TOWN OF YORKTOWN PLANNING BOARD

PUBLIC MEETING AGENDA YORKTOWN TOWN HALL BOARD ROOM 363 Underhill Avenue, Yorktown Heights, NY 10598

January 10, 2022
7:00 PM

C002

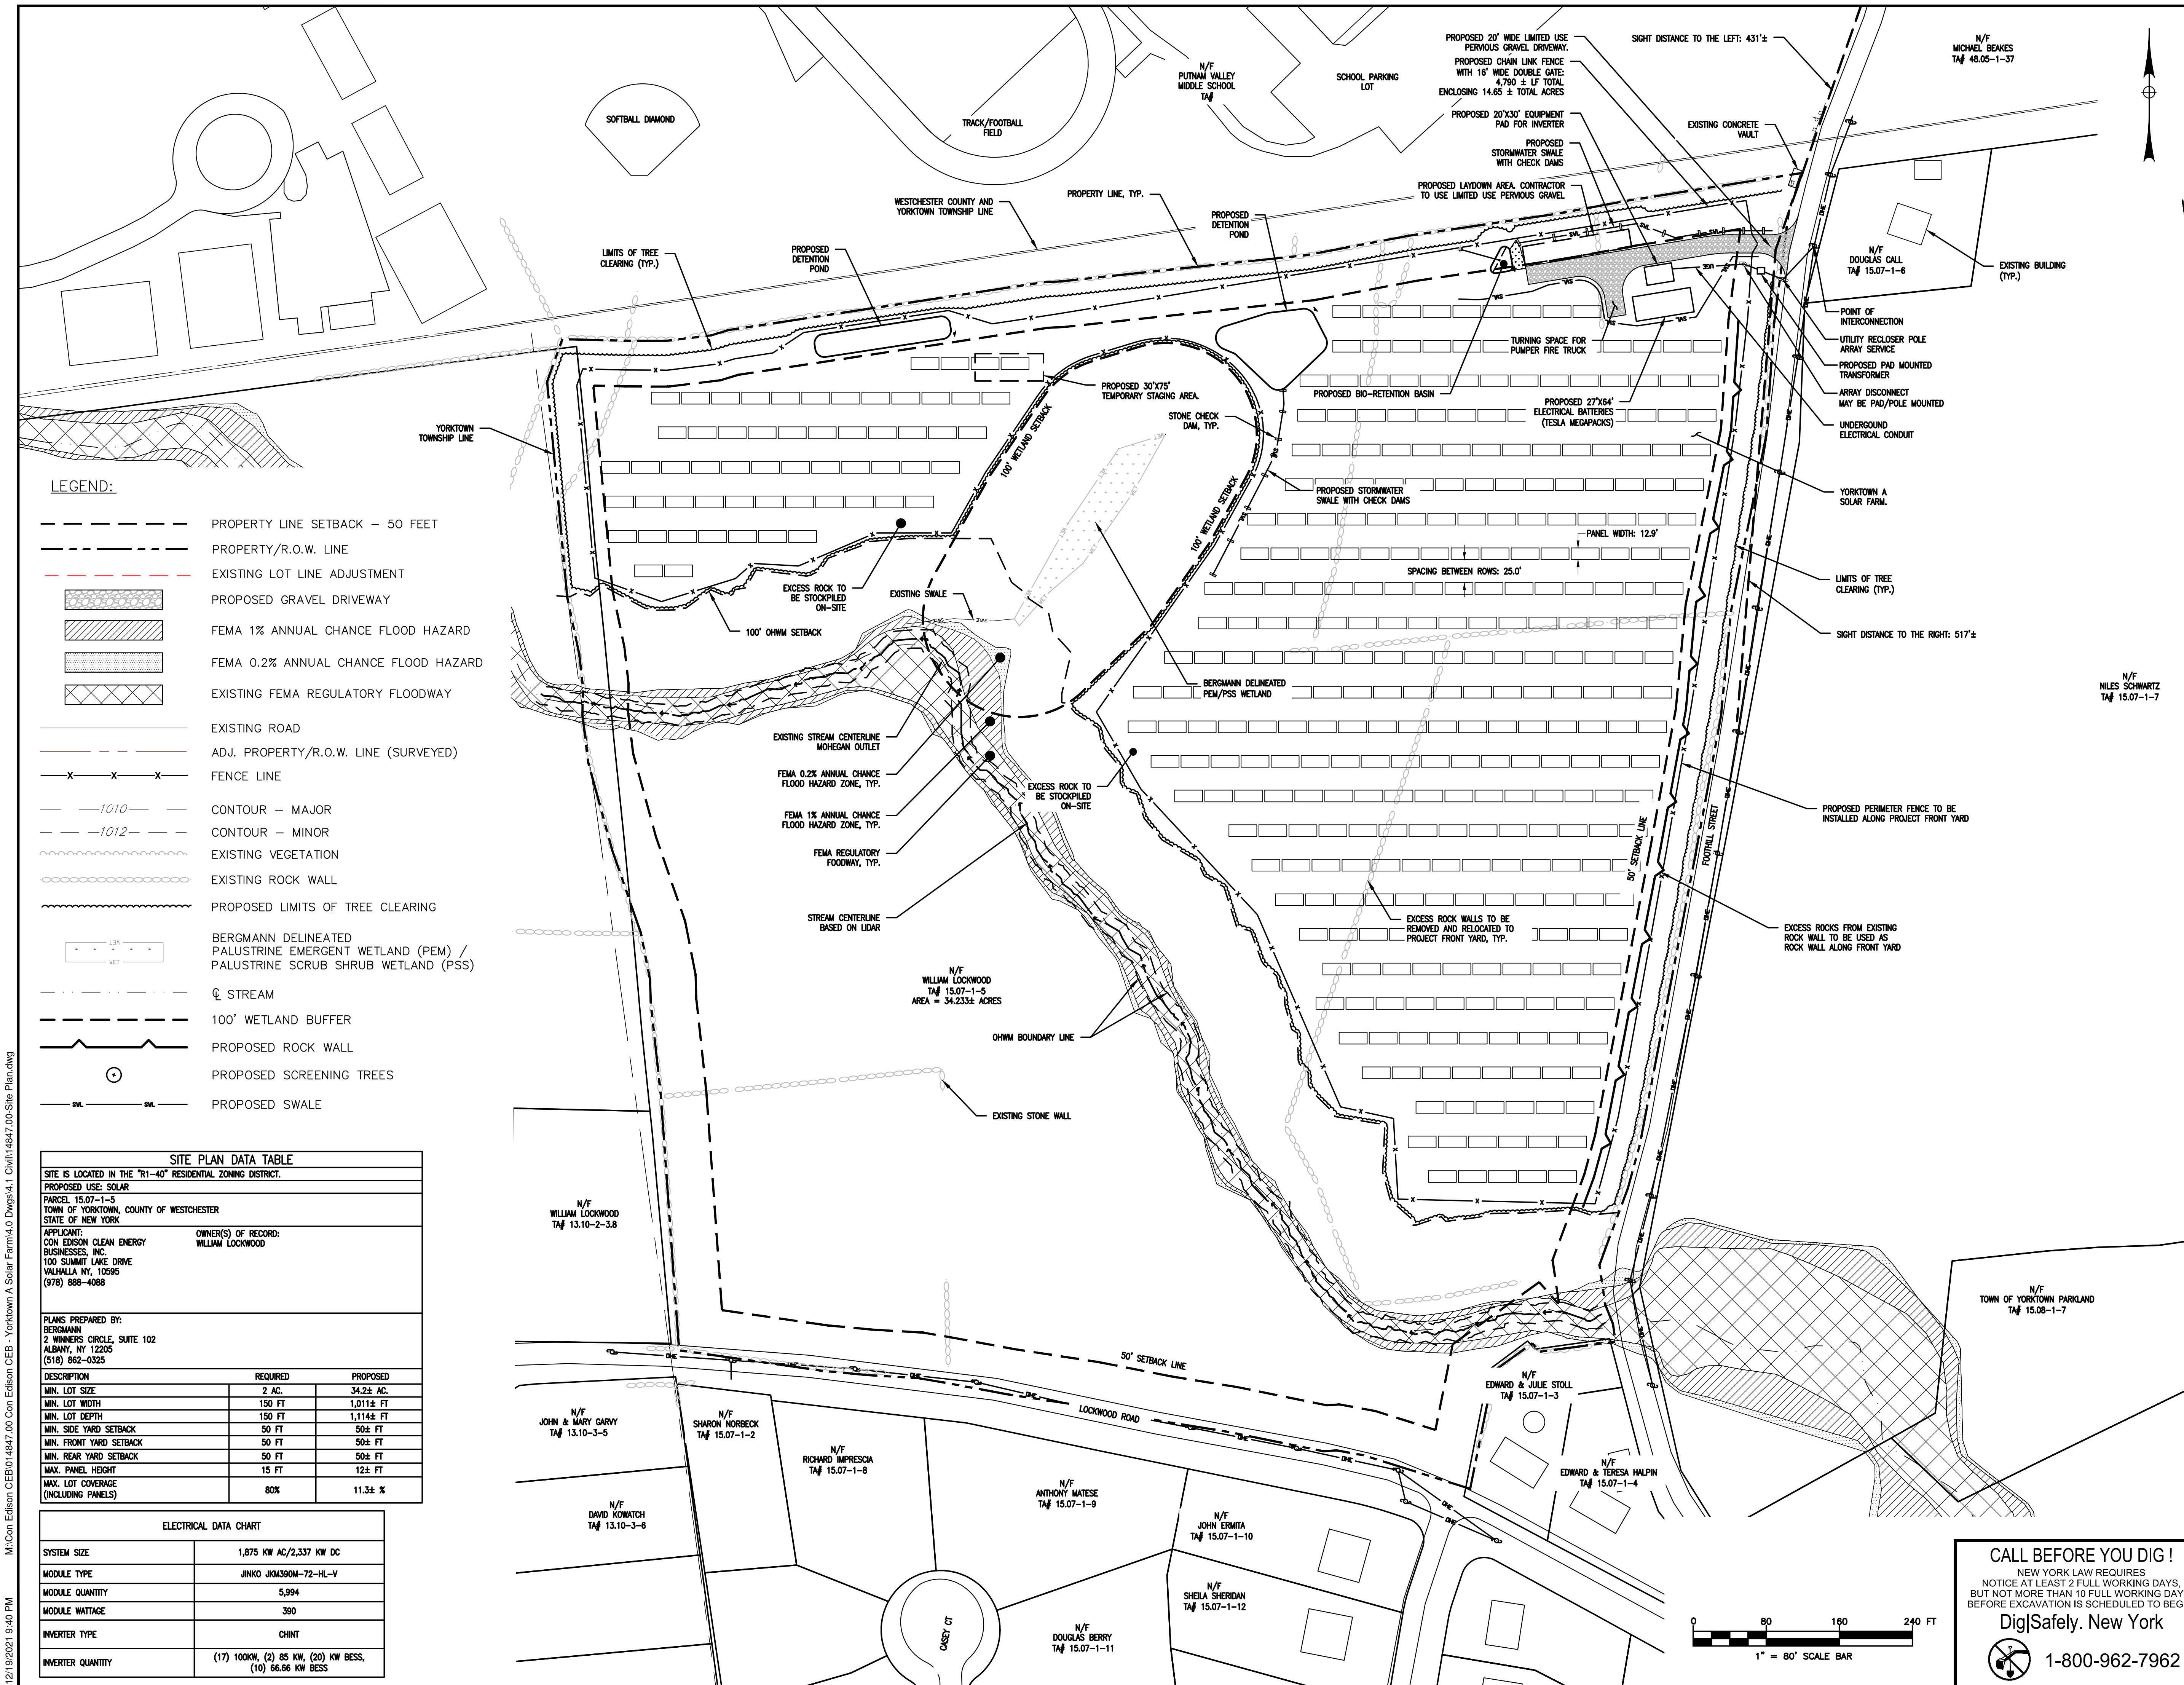
5. The submittal does not contain a plan showing the protected woodlands to be disturbed. Chapter 270-8.C.(1)(b) requires that applications contain a plan that shows "Within the proposed area of disturbance the location of existing protected woodlands." Furthermore, Chapter 270-8.C.(1)(c) requires a plan that shows "The square footage and boundaries of protected woodlands that will be disturbed." The submittal does contain a drawing C002 – SITE PLAN that has notes on it that says "LIMITS OF TREE CLEARING (TYP.)" If this is the line of protected woodlands, it should say so.

5. The submittal does not contain a plan showing the protected woodlands to be disturbed. Chapter 270-8.C.(1)(b) requires that applications contain a plan that shows "Within the proposed area of disturbance the location of existing protected woodlands." Furthermore, Chapter 270-8.C.(1)(c) requires a plan that shows "The square footage and boundaries of protected woodlands that will be disturbed." The submittal does contain a drawing C002 – SITE PLAN that has notes on it that says

C006

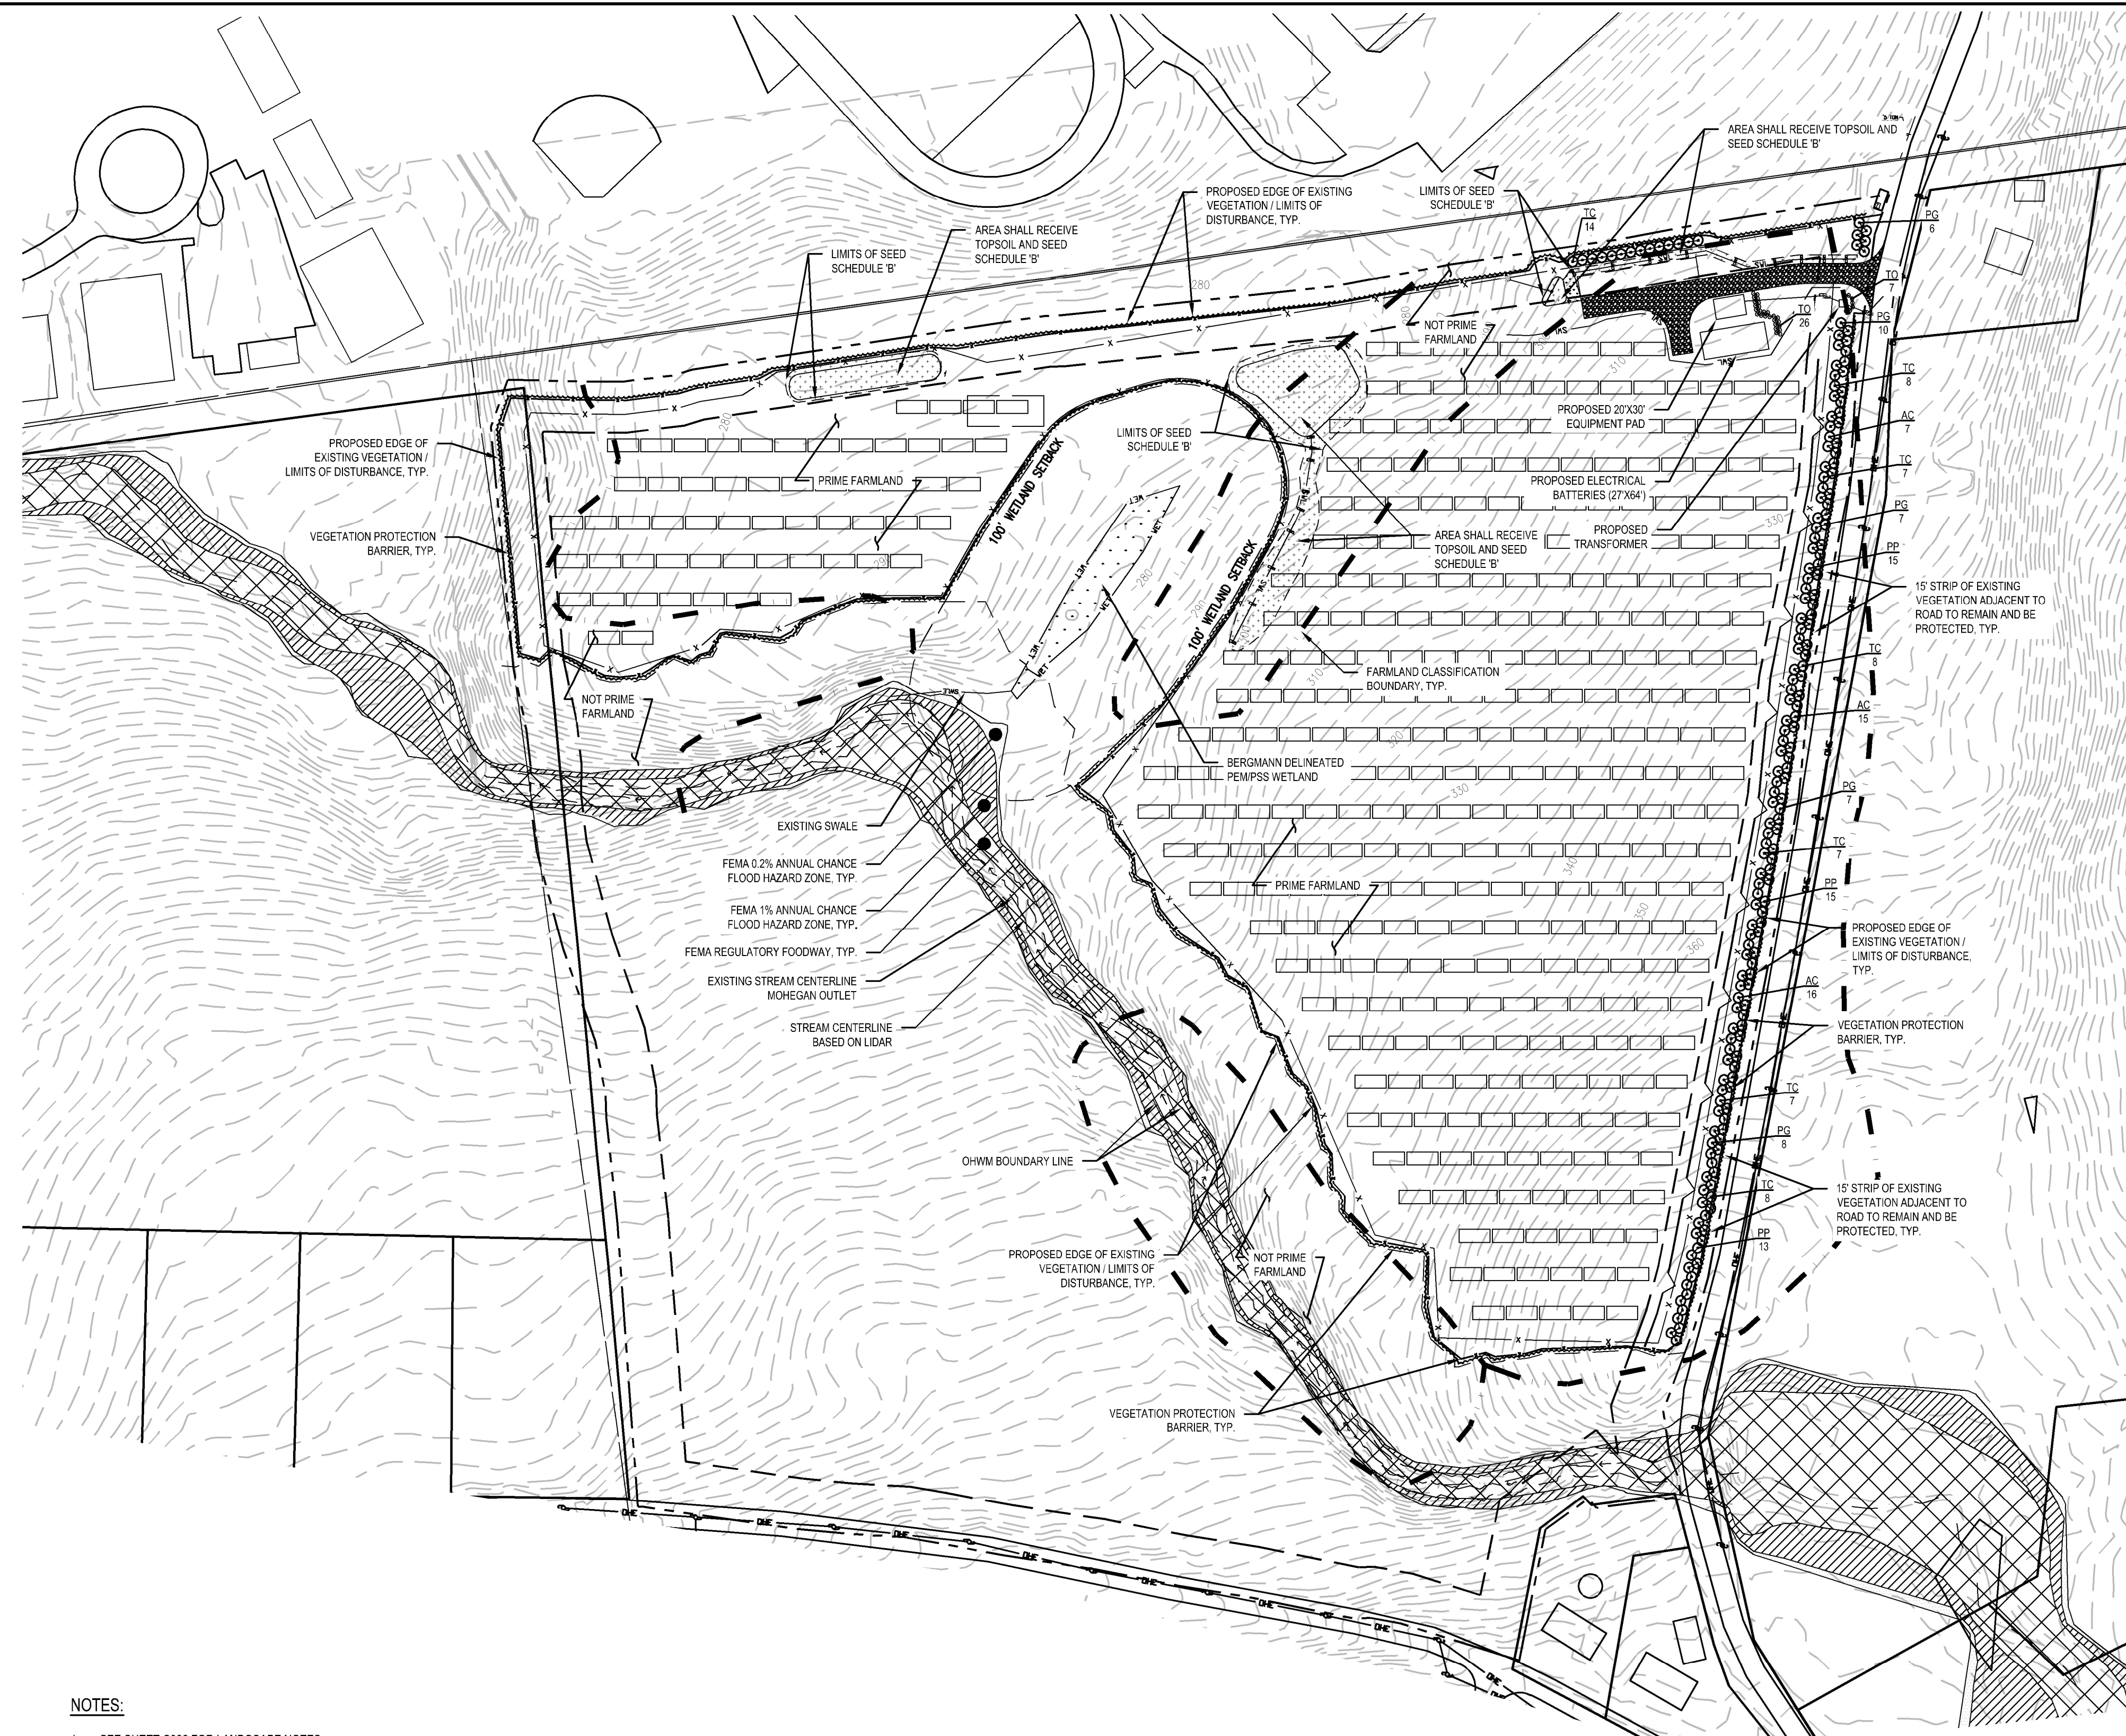
1. The submittal includes a drawing C006 – LANDSCAPING & PLANTING FOR MITIGATION PLAN. This plan shows the developer is proposing to plant 179 evergreen trees and 33 evergreen shrubs. Considering that a very large number of trees are to be removed and significant protected woodlands will be disturbed, the TCAC's position is that this mitigation is inadequate. Chapter 270-10.B.(1) states "All nonadministrative permits require mitigation." Chapter 270-10.D.(1) states "The approval authority shall require the preparation of a mitigation plan". According to Chapter 270-4's definition of a MITIGATION PLAN states ".... The goal of such plan is to replace the functions carried out by the protected trees and woodlands affected by the proposed activity." A revised mitigation plan must be submitted. Chapter 270-10.C.(1) through (5) gives options for mitigation.

2. Furthermore, drawing C006 shows the proposed plantings "INSTALLED SIZE" in heights not DBH. This needs to be corrected so that a mitigation ration (sic) can be calculated.

1. The submittal includes a drawing C006 – LANDSCAPING & PLANTING FOR MITIGATION PLAN. This plan shows the developer is proposing to plant 179 evergreen trees and 33 evergreen shrubs. Considering that a very large number of trees are to be removed and significant protected woodlands will be disturbed, the TCAC's position is that this mitigation is inadequate. Chapter 270-10.B.(1) states "All nonadministrative permits require mitigation." Chapter 270-10.D.(1) states "The approval authority shall require the preparation of a mitigation plan" . According to Chapter 270-4's definition of a MITIGATION PLAN states ".... The goal of such plan is to replace the functions carried out by the protected trees and woodlands affected by the proposed activity." A revised mitigation plan must be submitted. Chapter 270-10.C.(1) through (5) gives options for mitigation.

2. Furthermore, drawing C006 shows the proposed plantings "INSTALLED SIZE" in heights not DBH. This needs to be corrected so that a mitigation ration can be calculated.
